Knit Radix Ltd.

09th January 2017

Observations

Observations: Factory Building

Layout Plan

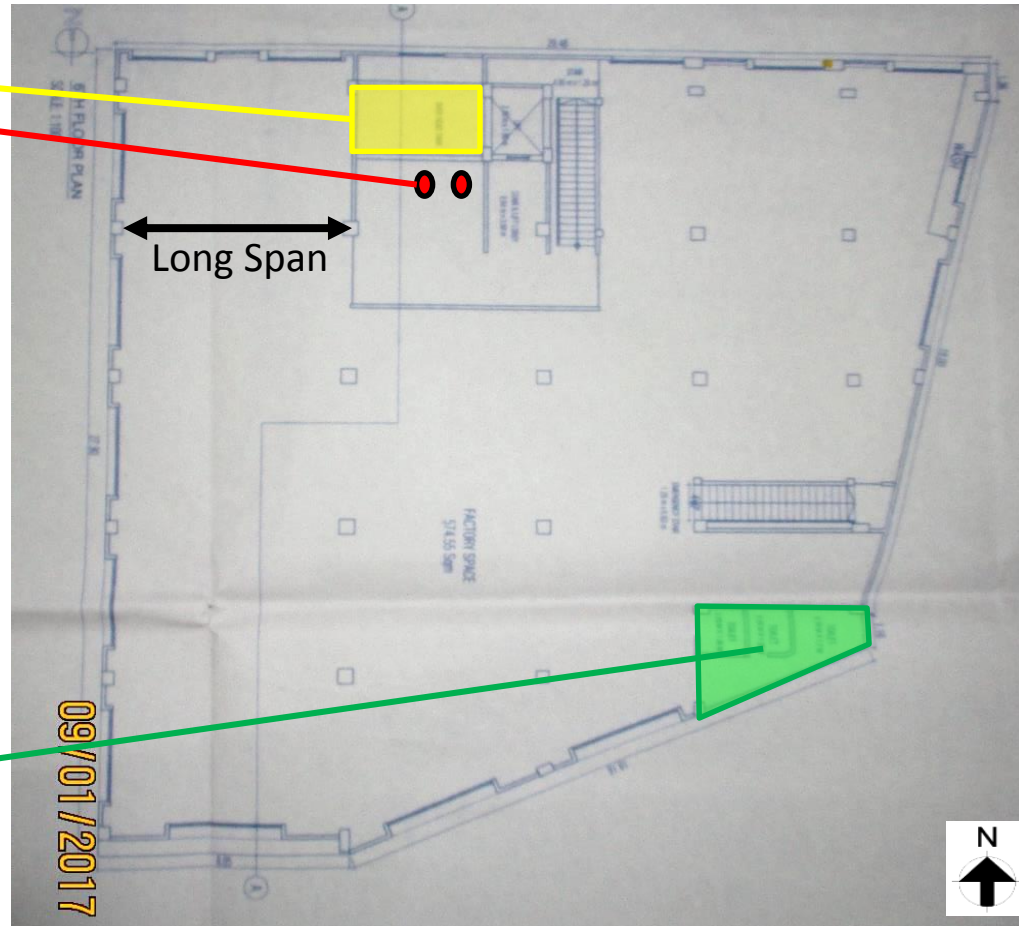
Column to be stressed above normal design limits

Cursory calculations indicate that the working stress of the ground floor columns are at a level that requires design review.

Item No.	Observation	Recommended Action Plan	Recommended Timeline
1	Column to be stressed above normal design limits	Factory Engineer to review design, loads and columns stresses.	6-weeks
2	Column to be stressed above normal design limits	Verify in-situ concrete stresses by 100mm dia. cores from min. 4 no. column from ground floor level.	6-weeks
3	Column to be stressed above normal design limits	Produce and actively manage a loading plan for all floor plates within the factory giving consideration to floor capacity and column capacity.	6-weeks
4	Column to be stressed above normal design limits	Make any structural alterations as advised by Building Engineer.	6-months
5	Column to be stressed above normal design limits	Continue to implement loading plan.	6-months
6	Discrepancies between provided drawings and on site condition	Building Engineer to survey as-built structure and prepare accurate as-built survey information for steel part.	6-weeks

Layout plan

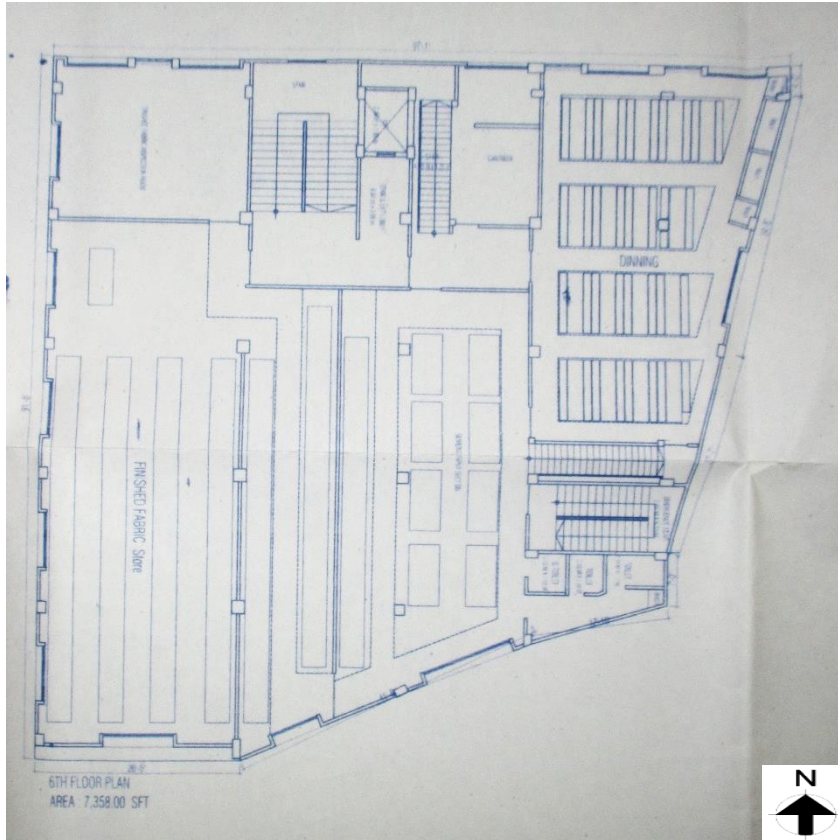
Discrepancies between provided drawings and on site condition

Steel beam size and thickness did not match with provided drawings as shown by red marking.

Column Layout

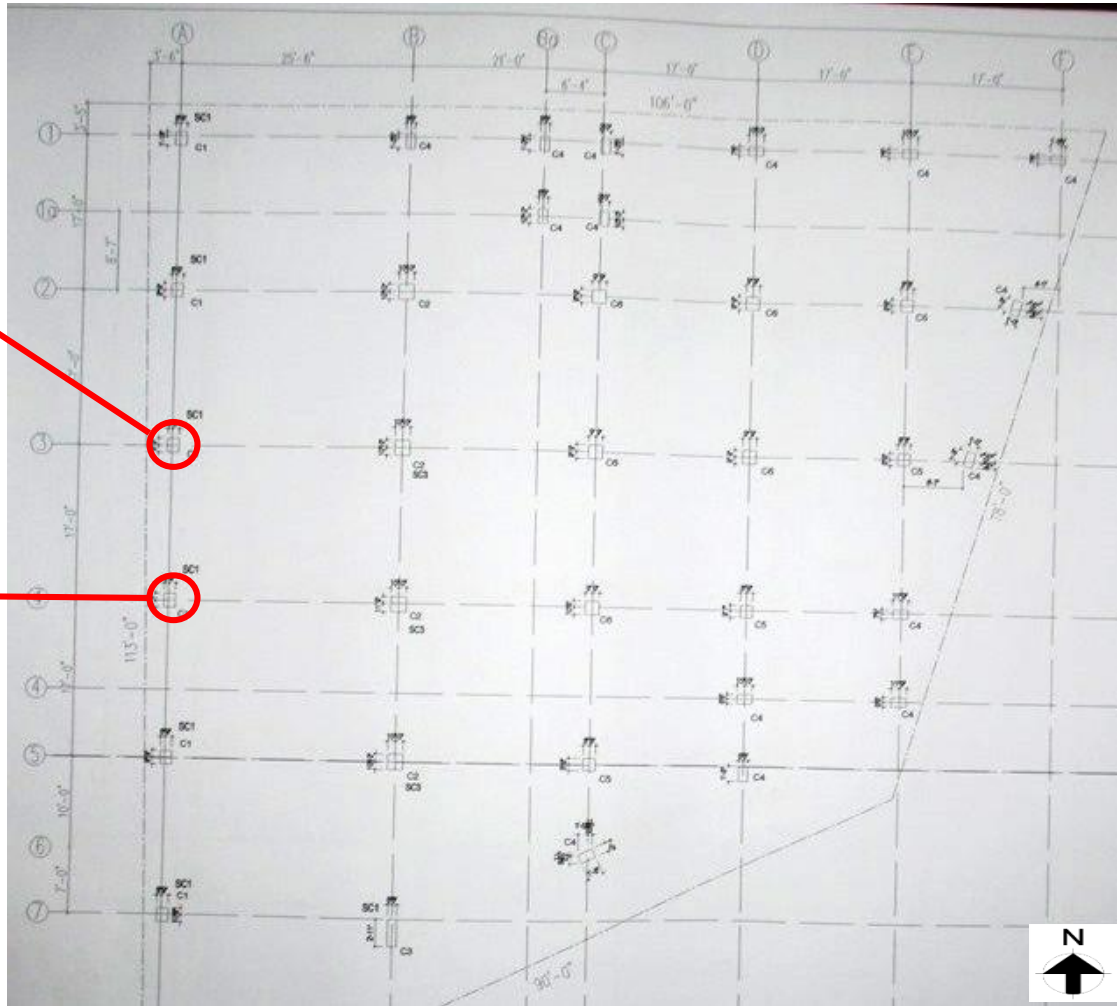
Columns susceptible to vehicle impact

Impact protection not provided to columns at loading –unloading area. Columns are susceptible to impact loading from vehicles.

7	Columns susceptible to vehicle impact	Install a barrier to prevent vehicle impact in column.	6-weeks
